Model: MET-C2ab		Date: 17-Apr-17	No.: RD0AD002
Subject: HE Model Installation Procedure		Prepared by: E.Hinata	
From: 1st Tech Service Sect., MFP/P Tech Service Dept.			
Classification:	<input type="checkbox"/> Troubleshooting <input type="checkbox"/> Part information <input type="checkbox"/> Action required <input type="checkbox"/> Mechanical <input type="checkbox"/> Electrical <input type="checkbox"/> Service manual revision <input type="checkbox"/> Paper path <input type="checkbox"/> Transmit/receive <input type="checkbox"/> Retrofit information <input type="checkbox"/> Product Safety <input checked="" type="checkbox"/> Other (New model) <input type="checkbox"/> Tier 2

Subject: New model release information: MP C3004ex/3504ex/4504ex/5504ex/6004ex, MP C2004ex/2504ex		Prepared by: A.Shigeta	
From: 1st Tech Service Sect., MFP/P Tech Service Dept.			
Classification:	<input type="checkbox"/> Troubleshooting <input type="checkbox"/> Mechanical <input type="checkbox"/> Paper path <input type="checkbox"/> Product Safety	<input checked="" type="checkbox"/> Part information <input type="checkbox"/> Electrical <input type="checkbox"/> Transmit/receive <input type="checkbox"/> Other ()	<in

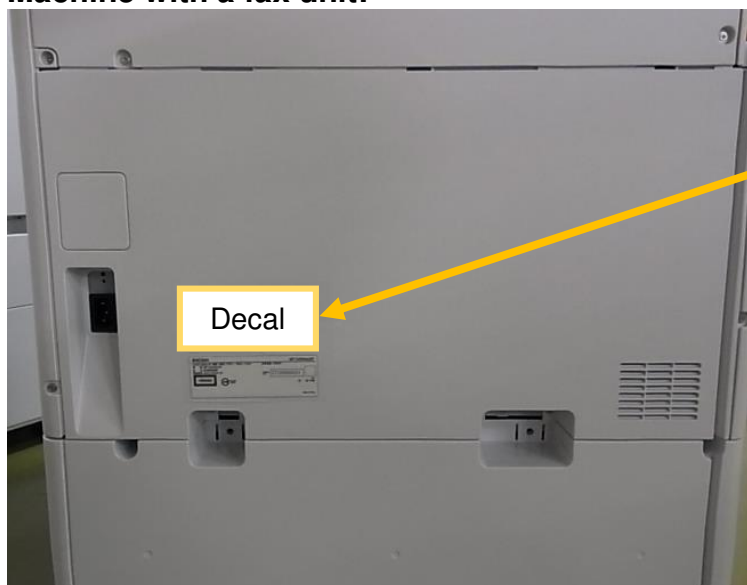
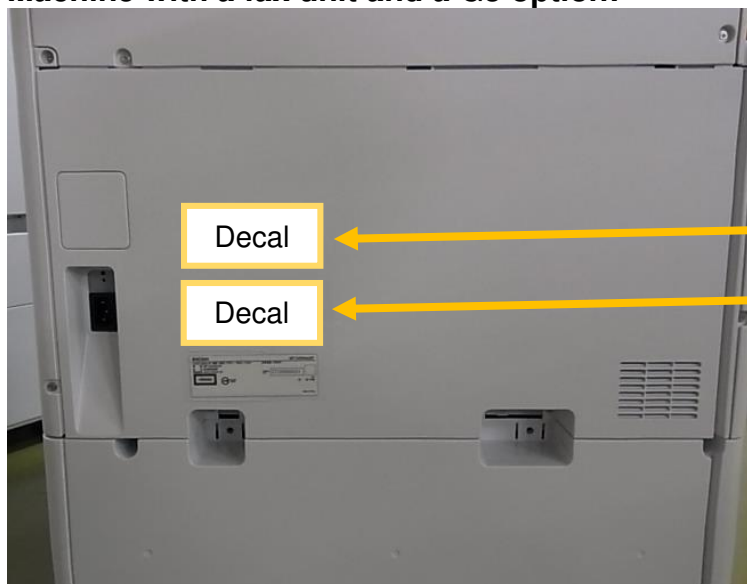
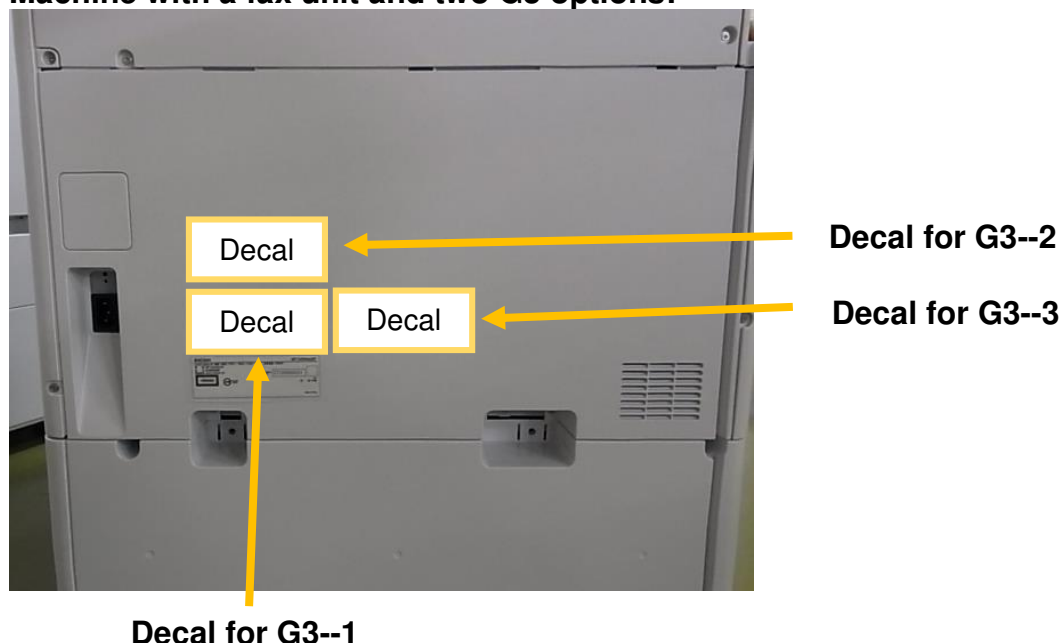
- The decal used to be attached to the bracket inside the machine at the factory until March 2017, but the revised regulation obliges us to attach it to the outer cover.

- Before the modification, the G3 option contained a decal for the double G3 boards as an accessory and another decal attached to the bracket. After the modification, two decals will be included as accessories.
- If the cover has to be replaced, reattach the decal(s) to the same position as shown below.

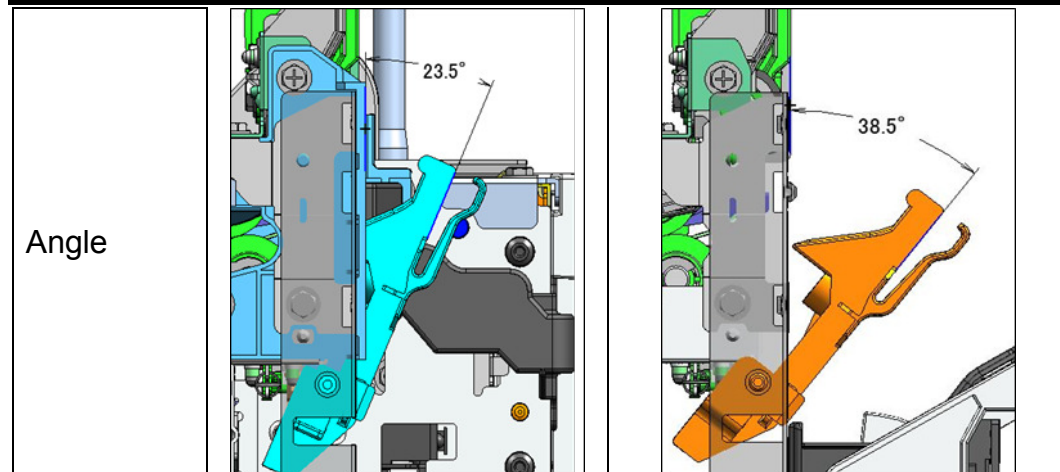
Change: The shape of the guide plate was changed.

1. Release the hook and remove the guide plate.

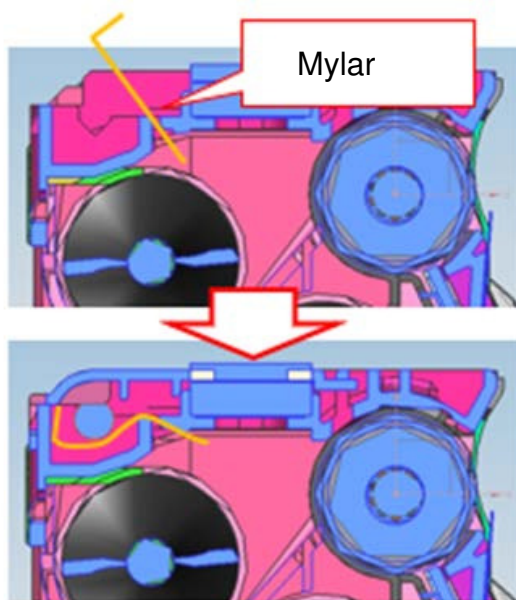
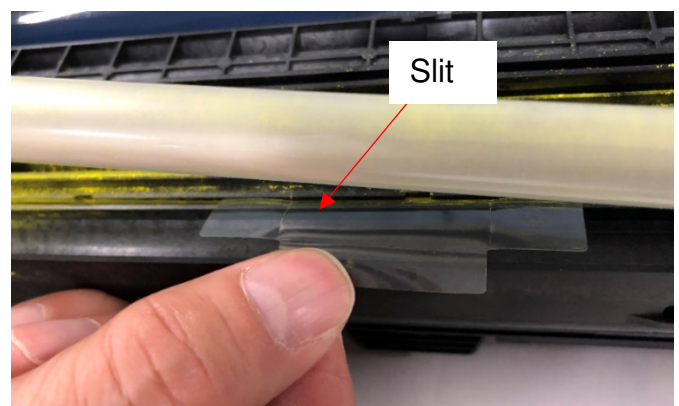
The following sheet was added to the development unit to secure the proper gap between the upper cover and development roller.

3. Insert the Mylar into the **slit** of the upper cover.

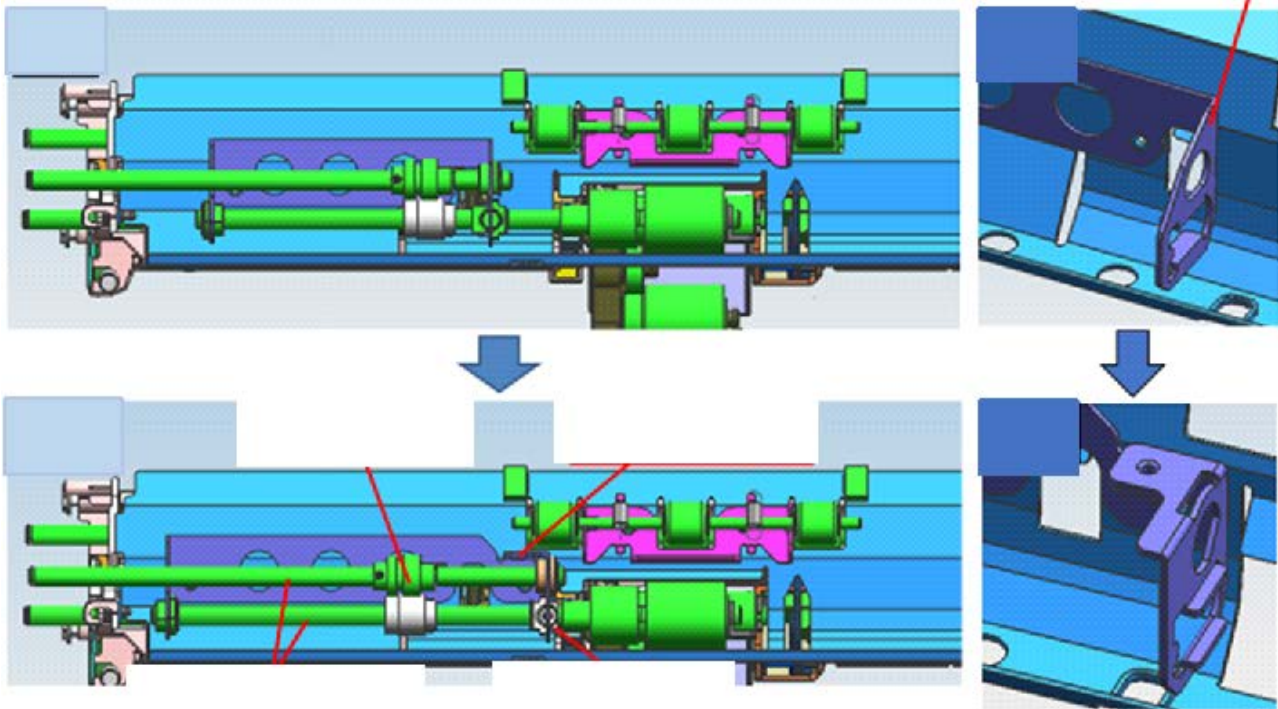
Change 3: The shape of the brackets and bearings, length of the roller shaft, and the gear position has changed. Also e-rings added.

Old P/N <Group B>	New P/N	Description	Int	Q'ty	Note
08050104	08050104	RETAINING RINGS-E:SILENCER:DIA4	-	2->3	C
D1494770	D0BQ2608	SHAFT:SEPARATOR:DRIVEN:ASS'Y	X/X	1	C
M0BW2615	D0BQ2615	GUIDE PLATE:SEPARATOR:ASS'Y	X/X	1	C
D1492619	D0BQ2619	SHAFT:SEPARATOR:DRIVE:ASS'Y	X/X	1	C
D2412653	D0BQ2653	COIL SPRING:PRESSURE:SEPARATOR	X/X	1	C

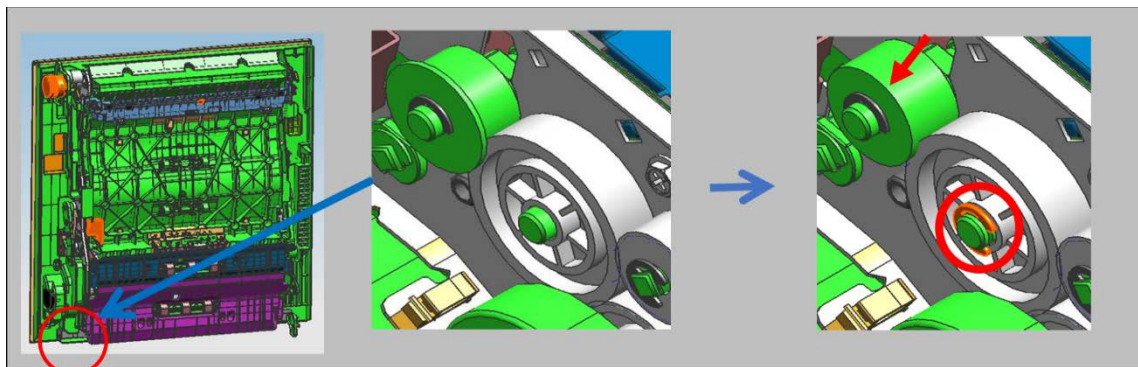
Change 4: There are no protruding parts to hold the gear. An e-ring added to stop the gear in position, and a groove added to the shaft for the e-ring.

Old P/N <Group B>	New P/N	Description	Int	Q'ty	Note
07200040E	07200040E	RETAINING RING - M4	-	3->4	D
D2414631	D0BQ4631	SIDE PLATE:REAR:DUPLEX:PEEN	X/X	1	D
D2414644	D0BQ4644	GEAR:MECHANICAL ROLLER CLUTCH	X/X	1	D

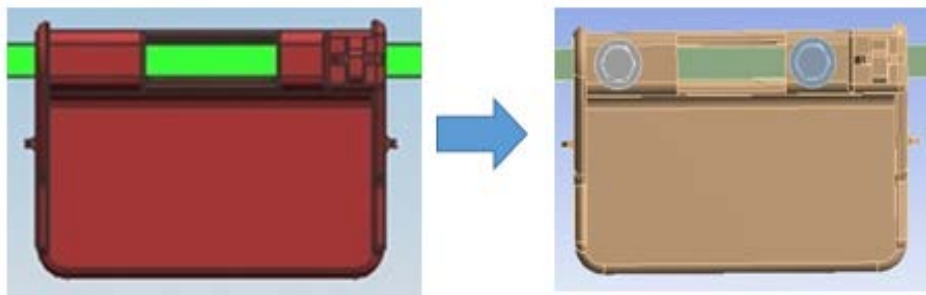
Change 5: The grip of duplex unit has been changed from press fit to screw type.

Old P/N <Group A/B/D>	New P/N	Description	Int	Q'ty	Note
-	03603006N	SCREW - M3X6	-	0->2	E
D1754654	D0BQ4654	SHAFT:LEVER:LOCK	X/X	1	E
D1494655	D2894655	GRIP:DUPLEX UNIT	X/X	1	E
